SUBJECT: Beaver Valley Power Station - Unit No. 2
Docket No. 50-412
Fire Protection Draft SER Open Items

BEAVER VALLEY POWER STATION - UNIT 2
RESPONSES TO AUXILIARY SYSTEMS
BRANCH REQUEST FOR ADDITIONAL INFORMATION

FIGURE A5-15
ALTERNATIVE SHUTDOWN CAPABILITY
COMPLIANCE TO BTP CMEB 9.5-1
BEAVER VALLEY POWER STATION-UNIT 2
FIRE PROTECTION EVALUATION REPORT

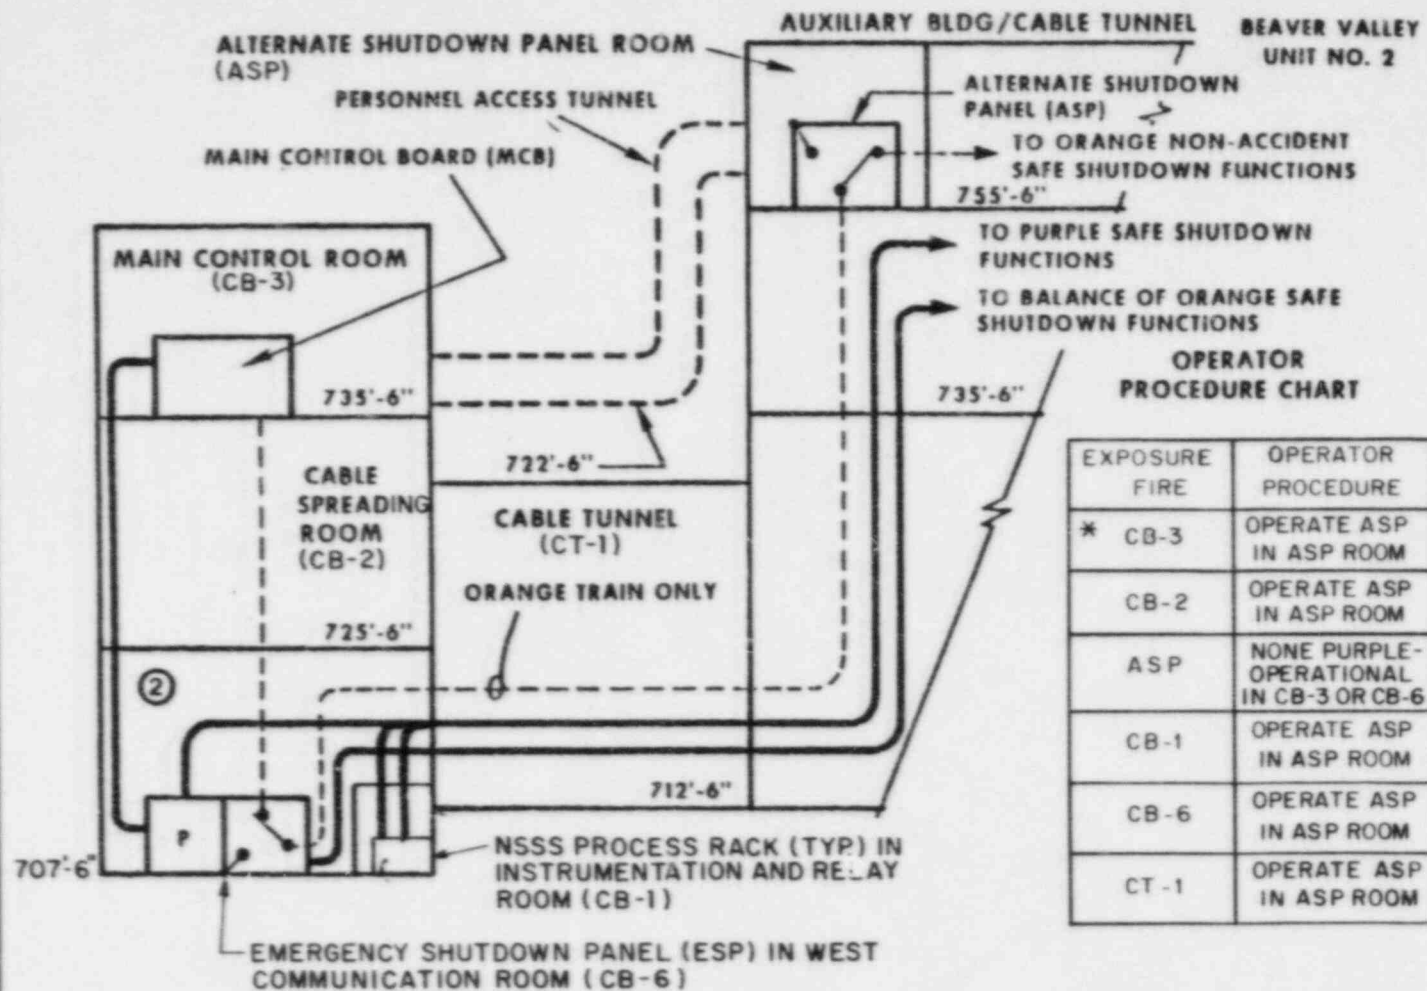
Question 410.57

Section 2.5.3 of the Beaver Valley Unit 2 Fire Protection Evaluation Report indicates that the postulated control room fire is limited to the ignition of one train of safety-related panel wiring. Section 7.4.1.3 of the FSAR indicates that a control room fire is not postulated to generate spurious or unwanted control signals which would prevent establishing hot standby from the emergency shutdown panel (ESP). In addition to above, Figure A5-15 - alternate shutdown panel, contains a note that states "To date, an exposure fire is not postulated in the control room, only loss of habitability."

Standard Review Plan, Section 9.5.1, which incorporates the criteria of Appendix R to 10 CFR 50 requires that the fire hazards analysis include exposure fires which could damage both trains of safe shutdown systems if they are located in a single fire area and not sufficiently separated. Further, the assumptions that spurious or unwanted control signals will not result from fire damage is not consistent with the SRP criteria. Based on the above criteria for the control room:

- a. Revise your submittal "Fire Protection Evaluation Report" and identify any necessary modifications to assure that fires will not affect the safe shutdown capability as indicated by the above criteria, or
- b. Provide justification for your position and identify any resulting deviation from the above criteria.

Figure A5-15 of Appendix A5 of the FPER has been revised (attached) to indicate that the ASP room (alternative shutdown area) is used in the event of an exposure fire in the main control room (CB-3), as well as during an exposure fire in any of the previously mentioned four fire areas, i.e.; CB-1, CB-2, CB-6, and CT-1.
